<p>Owner</p> <p>Linda G. Kassof CD83 Contractor's Business Park, Ltd.</p>	<p>Property Location: 2140 N. John Young Pkwy., south of Silver Star Rd., west of N. John Young Pkwy., and north of W. Princeton Rd. ±40.94 acres (District 5).</p>	<p>Staff's Recommendation: Approval of the request subject to the conditions in the staff report.</p>
<p>Applicant</p> <p>Edgardo Garcia-Luna, Lochrane Engineering</p>	<p>Applicant's Request: Part C. Framework Master Plan request to allow three (3) commercial outparcels (lots 2, 3 & 4), an interior service road and storm water ponds on a 15.82 ac. portion of property and a Specific Parcel Master Plan to allow 5 warehouse/storage buildings (up to +176,025 sq. ft.), on lot 1 of the subject property.</p>	<p>Public Comment Courtesy notices were mailed to property owners within 300 ft. of the subject property the week of February 5, 2018. As of the published date of this report, staff has not received any comments from the public concerning this request.</p>

<p>Project Planner</p> <p>Jacques Coulon Planner II</p>	<p>Updated: February 9, 2018</p>

Project Analysis

Project Description

Lot 2-4 Site Plan (Framework)

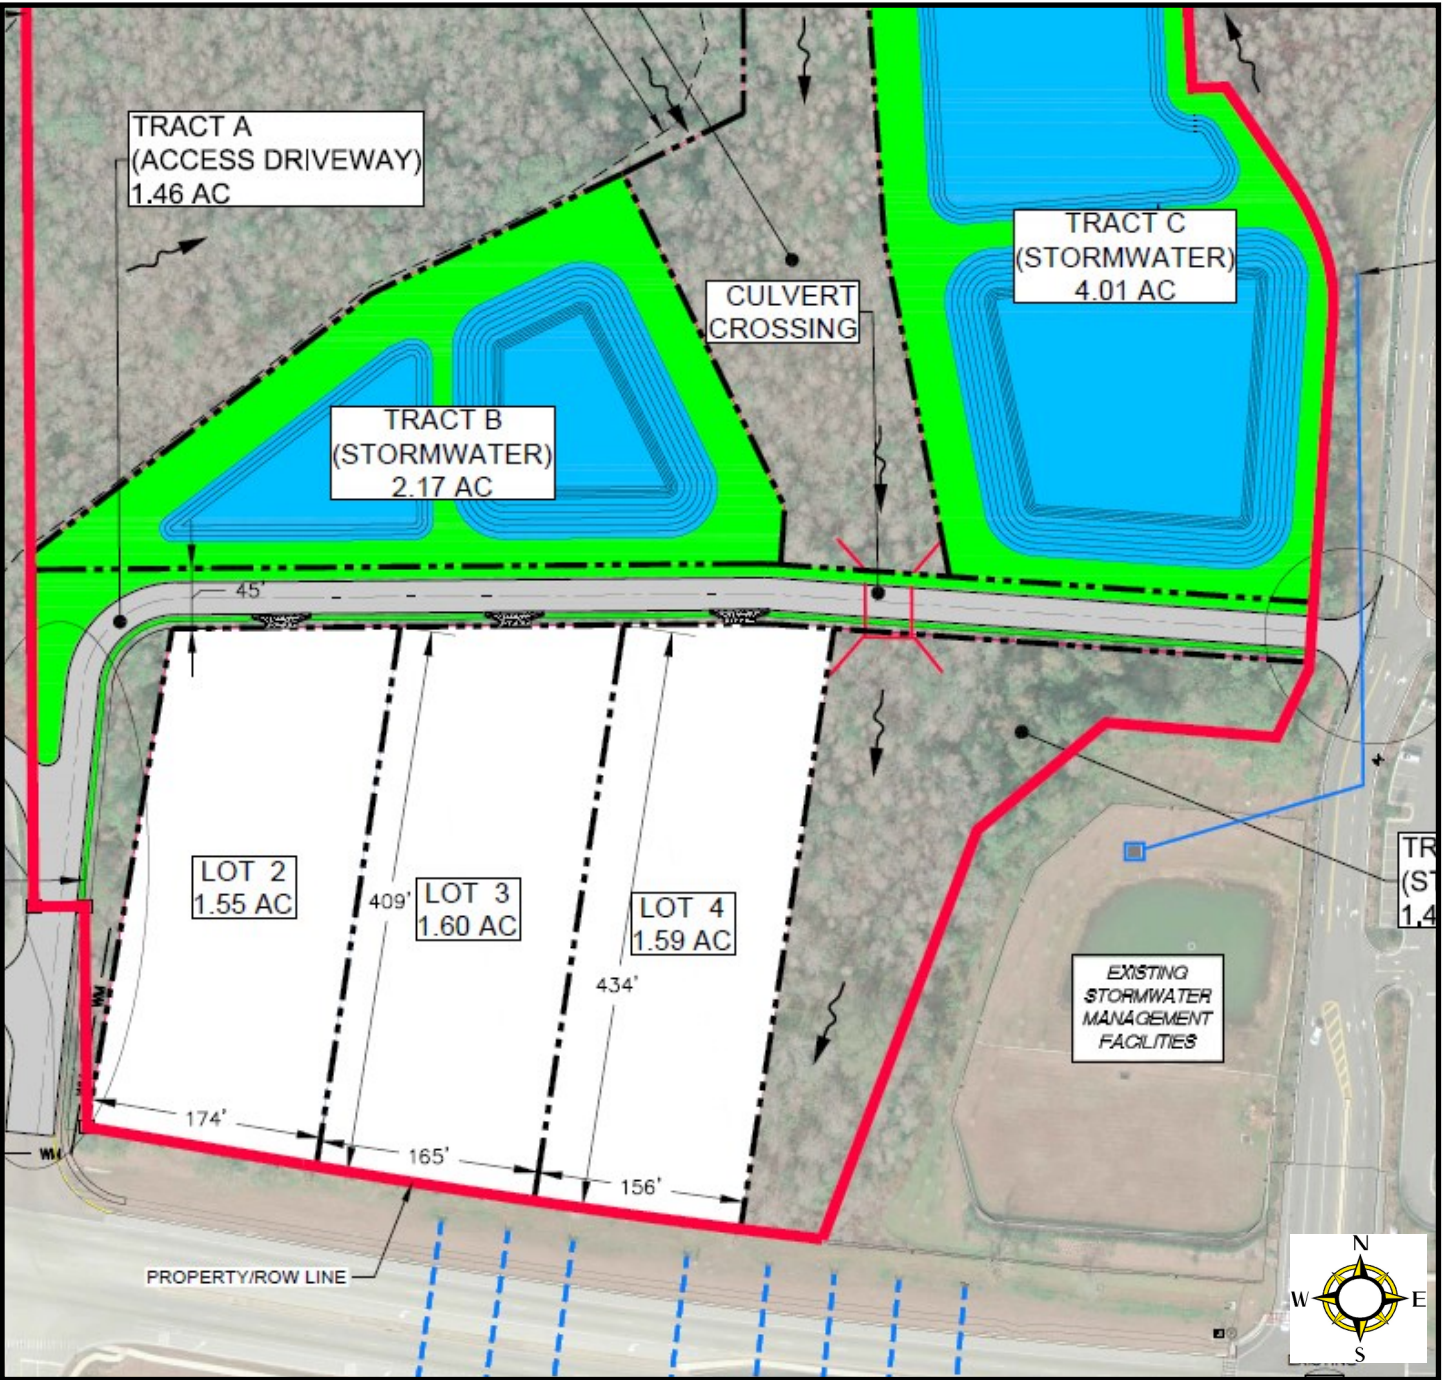
As part of this petition approval is being sought for a framework master plan to cover the entire site and a specific parcel master plan for phase 1 located at the northeastern corner of the site. Outside of phase 1 the applicant is seeking to place a driveway from W Princeton St. north along the western edge of lot two, the driveway will turn east to run to the rear of lots 2 through 4 before connecting with the existing access drive for the Wal Mart site. Pedestrian access from W Princeton St. to each of the 3 lots in phase 2 will be required at the time of phase 2 development.

4. Lots 2-4: Principal buildings must be located close to Princeton Street, with not more than one row of parking spaces between the buildings and Princeton.

5. Lots 2-4: The principal buildings must have architecturally highlighted public entrances oriented to Princeton Street, and at least 30% transparency in the Princeton Street facades.

Lot 1 Site Plan (SPMP)

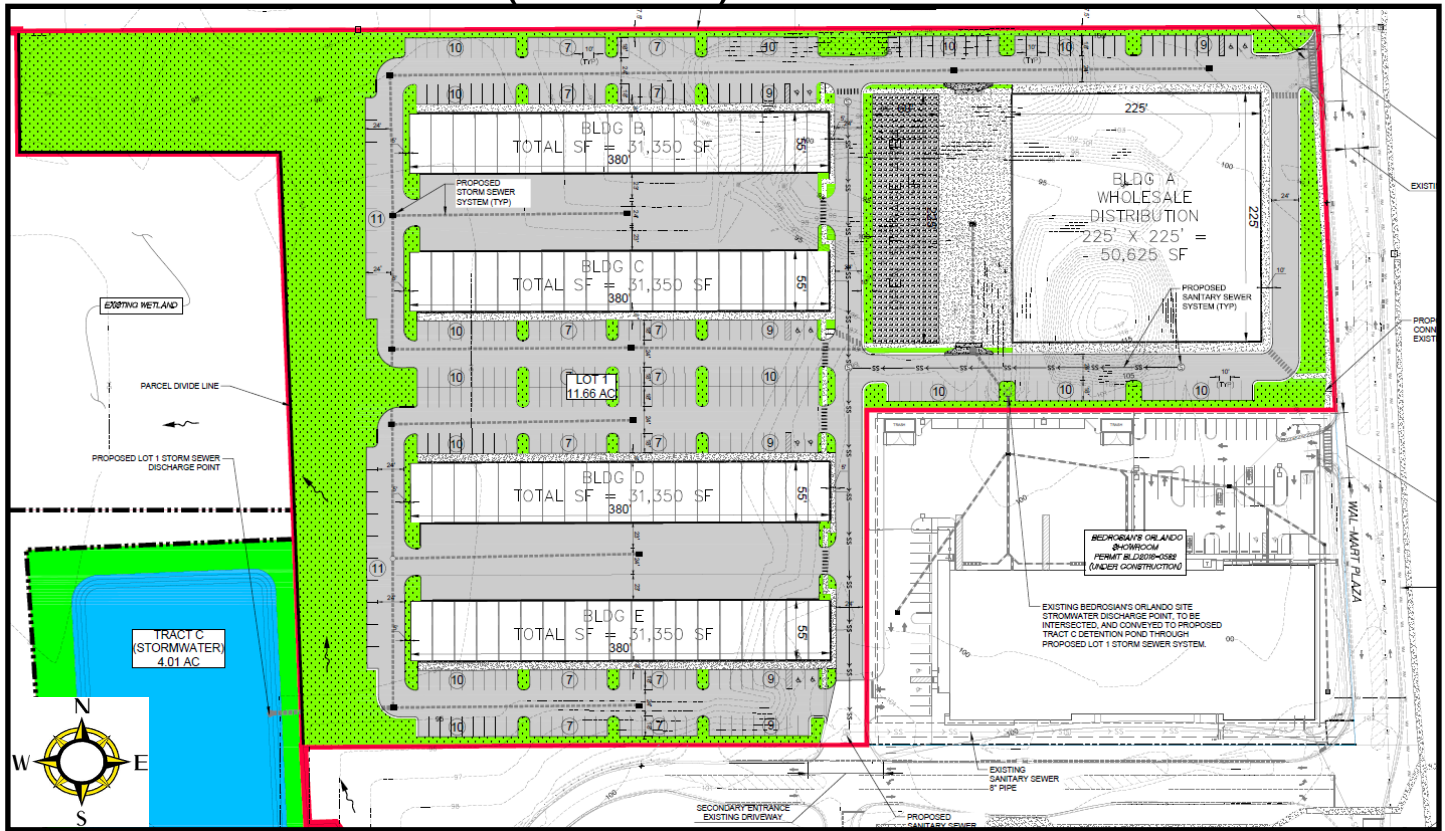
The subject property is zoned AC-2/W and Conservation. Should the proposed future land use amendment and rezoning be approved and adopted then the entirety of the subject property will be zoned AC-2/W. As detailed in Table 2, the applicant is seeking to meet all codes in regards to building setbacks and bufferyards. Note: A portion of the buffer at the northeast-

ern corner of the lot, along the north side of the most easterly handicap parking spaces) appears to be shallower than the required 7.5 ft. LDC Sec. 61.312 requires that all landscape areas adjacent to rights-of-way and property lines be a minimum of 7.5 ft. in depth.

In terms of phase 1 (the SPMP) the applicant is proposing to connect lot 1 to Wal Mart Plaza along the north eastern corner of lot one and to also connect to the existing east-west access drive running along the north side of the Wal Mart parking lot through a new access point directly to the west of the Bedrosian site; no new driveways or roadways are proposed in phase 1. A total of 176,025 sq. ft. of space divided between warehouse and warehouse/

distribution is proposed to be constructed as part of Phase 1. As shown in Table 4 a minimum of 107 parking spaces are required with a maximum of 616 parking spaces permitted. The applicant is seeking to provide 383 parking spaces between the five buildings of phase 1. The applicant has proposed a series of pedestrian pathways within the phase 1 area, including a north-south connection and east-west pedestrian connect.

1. A 5 ft minimum width pedestrian connection must be constructed between Bldg A and the sidewalk along Wal-Mart Plaza.
2. If the driveway north of Lots 2,3, & 4 is constructed as a private street instead of as a driveway, a 5 ft wide sidewalk must be constructed on both sides of the street.

3. A pedestrian path must be created connecting the sidewalk along the main driveway on the south of the property to the east entrances of Buildings B, C, D, & E. This path requires 9 ft between the edge of pavement and the east building facades with a 6 ft sidewalk and 3 ft of landscaping next to the building. ADA ramps and marked crosswalks are required at each drive aisle crossing.

Proposed Elevations– Building A

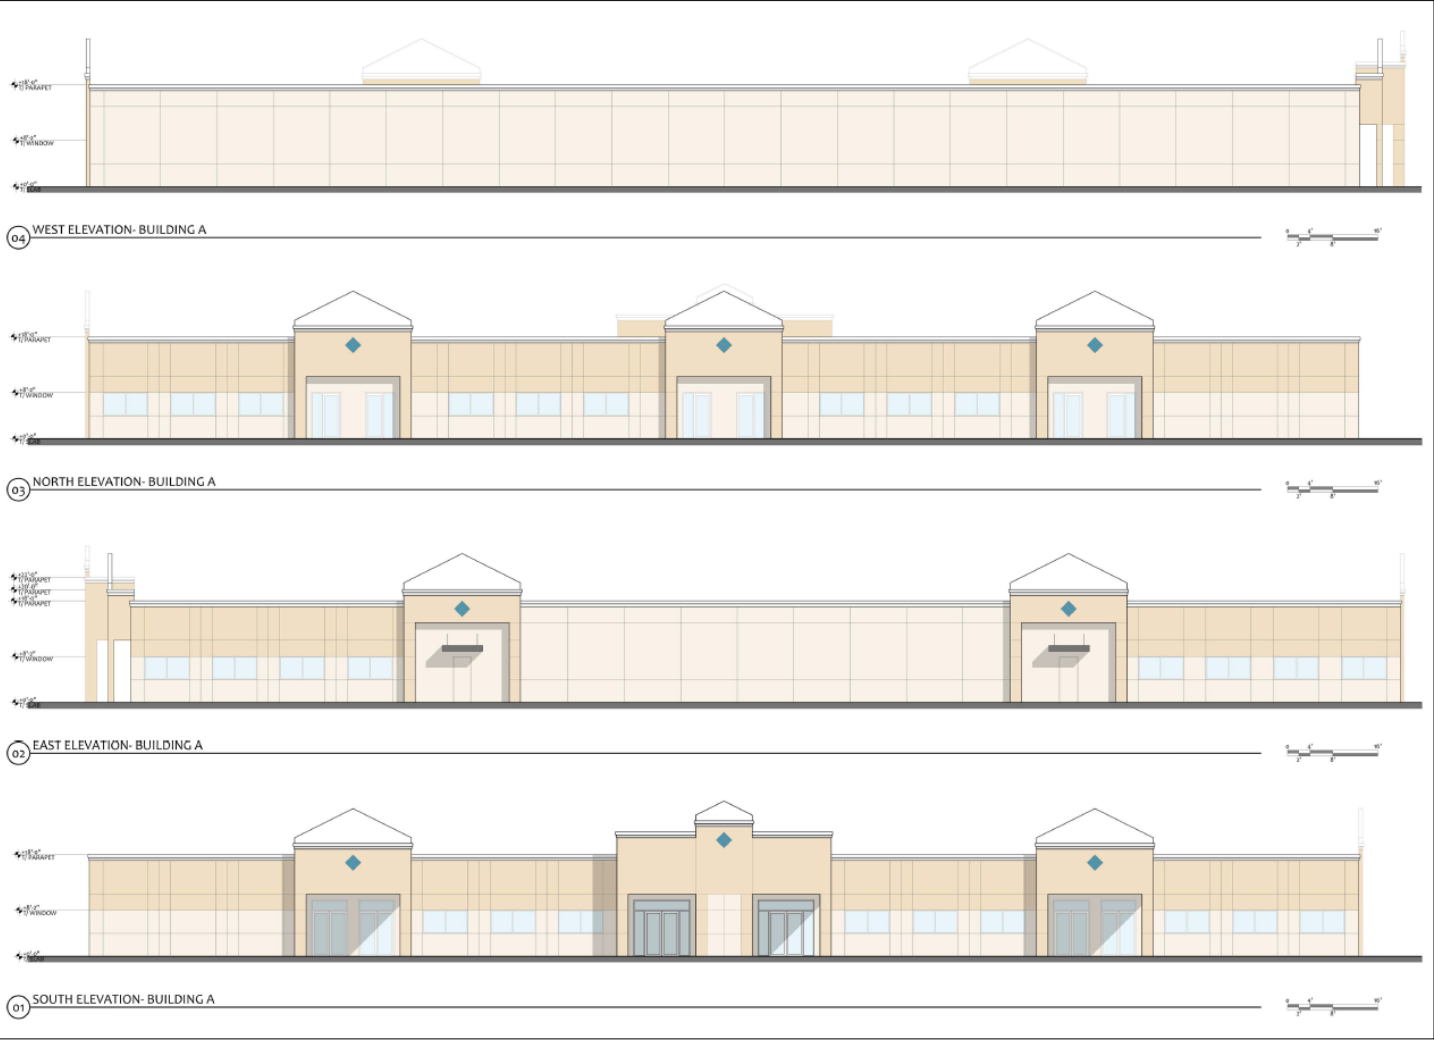
As previously noted the MPL application is two parts; a framework master plan covering the entire subject area and a SPMP covering just lot 1. Within the phase 1 SPMP, the applicant is seeking to build a single wholesale/distribution building (bldg. A) fronting on Wal Mart Plaza as well as 4 multi-tenet contractor's buildings (Bldgs. B-E) to the rear of the main building. Each of these buildings will be around 31,350 sq. ft. for a total of 125,400 sq. ft. within these 4 buildings. While Building A is proposed to be built towards Wal Mart Plaza that portion of the building fronting the street does not read as the front of the building. The design of the building makes it clear that this portion of the building is a side even though it will be the most prominent façade. The eastern façade of Building A must be enhanced to provide a better presence to Wal Mart Plaza, to have a more finished look to the façade. The front doors do not have to be moved to this façade to achieve this requirement; staff recommends that the applicant bring in some of the details used on the southern façade into the eastern façade. These elements can include the projections used in the center of the building, as well as the provision of additional glass.

3. Lot 1: The eastern elevation of building A must be updated to provide the appearance of a front elevation. While it may not functionally serve as the front of the building it must present the appearance of a front elevation. Additional details must be included such as windows, doors and other articulations to the façade to provide that front of building feel. The treatment from the south elevation can be carried out on this elevation as well.

Proposed Elevations— Buildings B and D

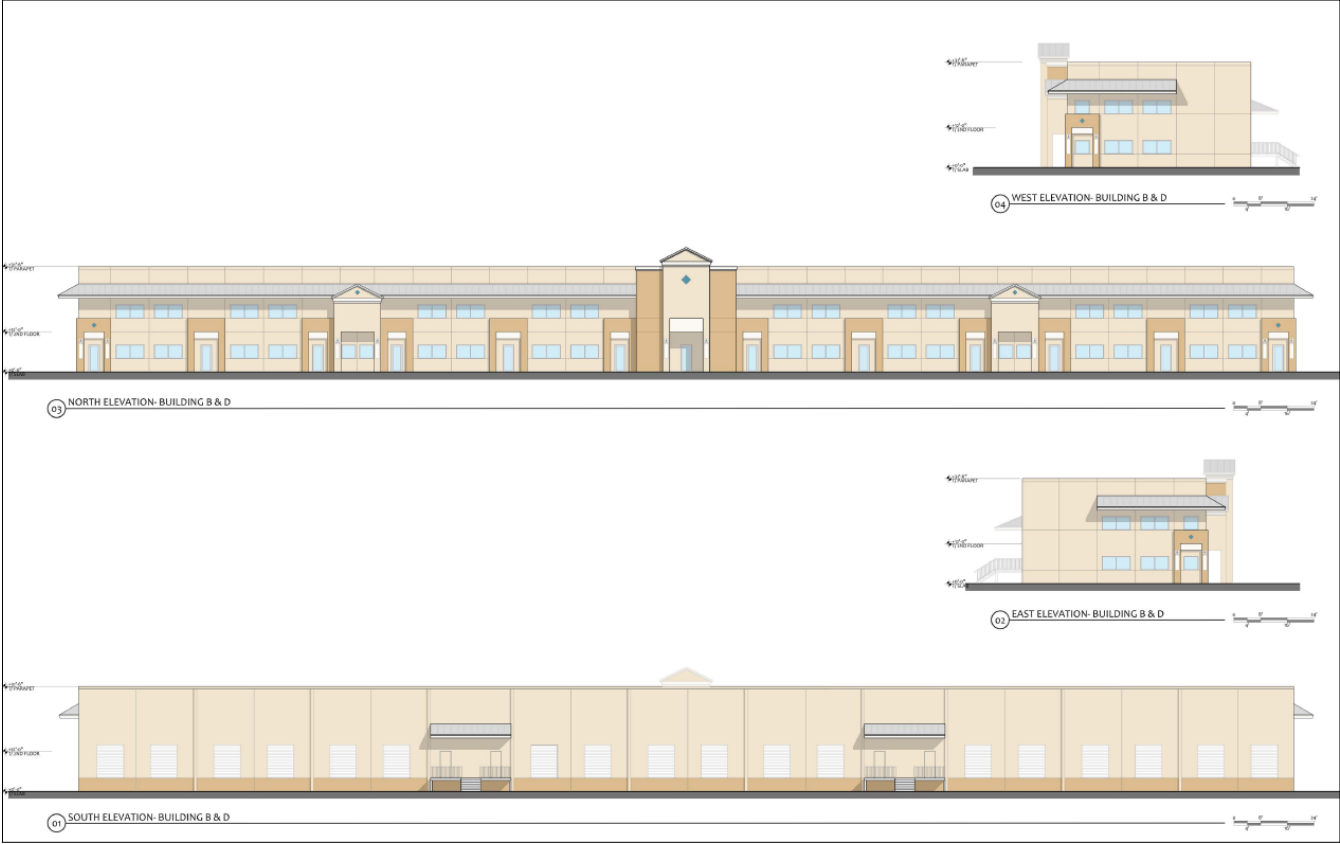
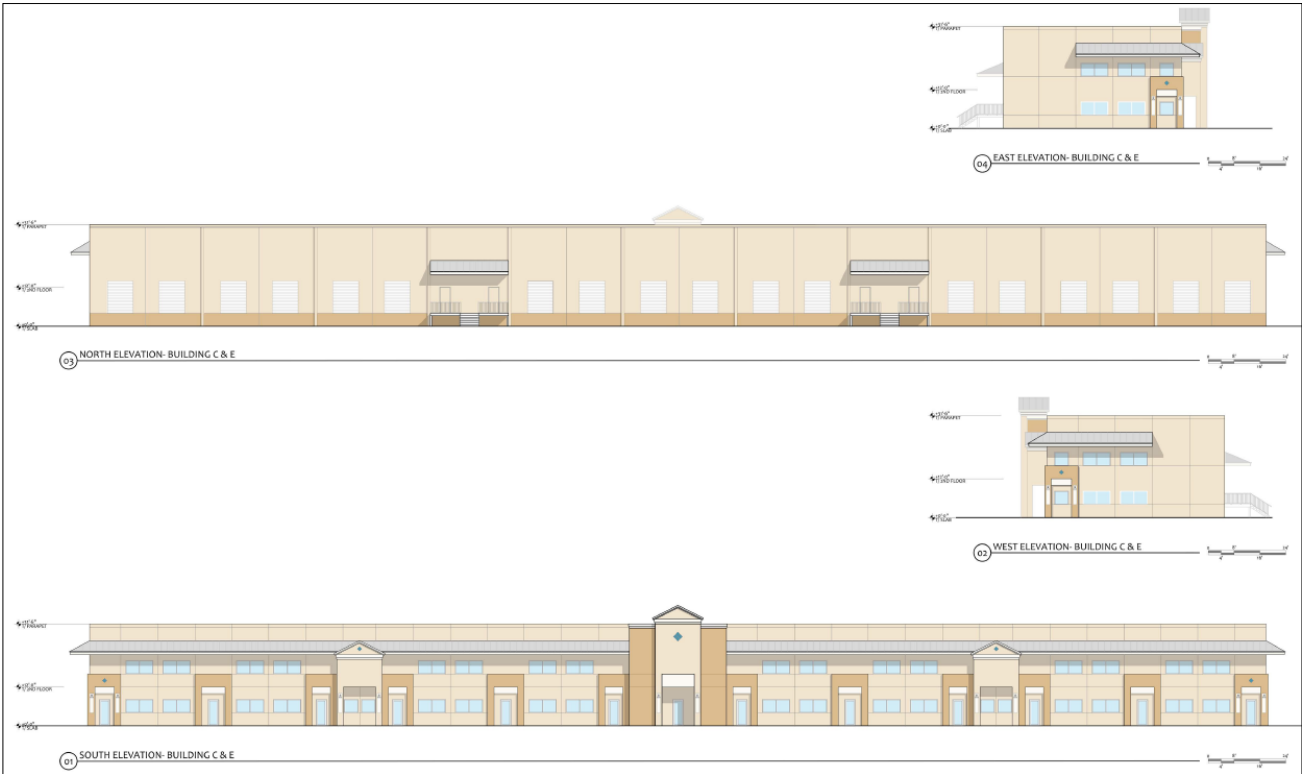
Generally the design for buildings B-E is appropriate for the use and location of the buildings. Staff will look closely at the details of the final design and landscaping during the appearance review to ensure consistency with the elevations pro-
